FALCON SERVICE BULLETIN

FALCON 7X

No 632

EDU INTERNAL BATTERY REMOVAL

Figure 1: EXTERNAL REMOVABLE BATTERY REPLACEMENT

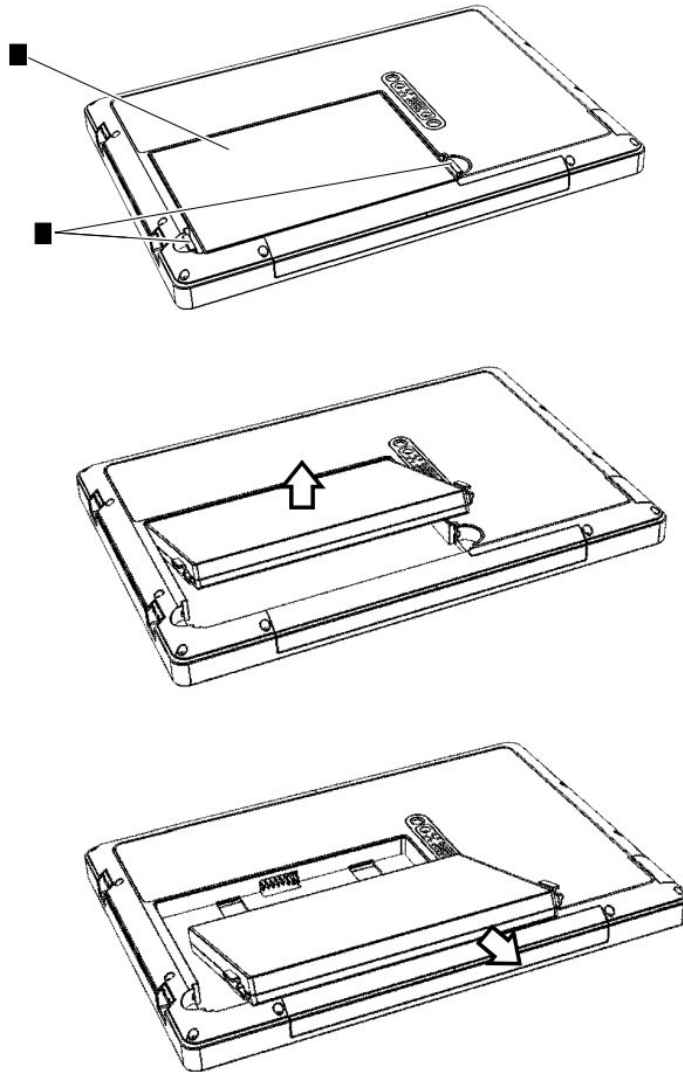
- (1) Obey the general maintenance and safety precautions ([TASK 20-00-00-910-801](#)).
- (2) Check the external removable battery for integrity (no swelling). If swelling is noticed, replace the battery :
 - Press the two clips ([1-fig. 1](#)) to unlock the battery ([2-fig. 1](#)).

- Remove the battery ([2-fig. 1](#)).
 - Install a new battery ([2-fig. 1](#)) in position.
 - Make sure that the clips ([1-fig. 1](#)) are engaged.
- (3) Get a software that can calculate CRC32 checksum (for example "7-zip File Manager").

Figure 2: BIOS CHECKSUM CALCULATION

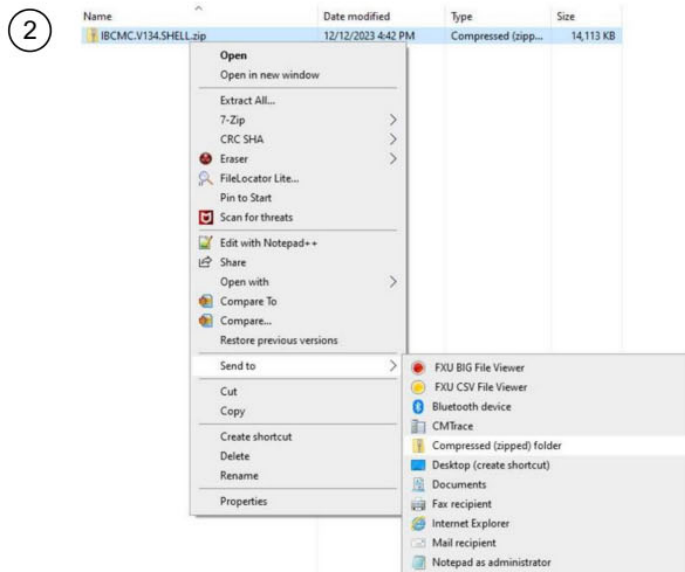
REASON: Modification of BIOS zip file CRC32 calculation.

- (3) Download the CMA-1310 AMI BIOS V134 software (file name: IBCMC.V134.SHELL.zip) from the Falcon Portal to a USB key (Refer to [3.B.](#)).
- (4) Proceed to BIOS zip file CRC32 calculation (for example with "7-zip" previously got) ([fig. 2](#)) as follows:

- If the "7-Zip / CRC SHA" functionality is available, perform the following steps:
 - right click on the ".zip" file, the "CRC SHA" menu, and then the "CRC-32" option ([1-fig. 2](#)),

- check that the "CRC-32" value is "560244EA".
 - If the "7-Zip / CRC SHA" functionality is not available, perform the following steps:
 - right click on the ".zip" file, then select "Send to a compressed folder" option ([2-fig. 2](#)),

- select "Yes" to create the .zip file on the desktop,
 - right click to open the .zip file on the desktop,
 - if necessary, right click in the explorer header to activate the "CRC-32" option ([3-fig. 2](#)),

- check that the "CRC-32" value is "560244EA".
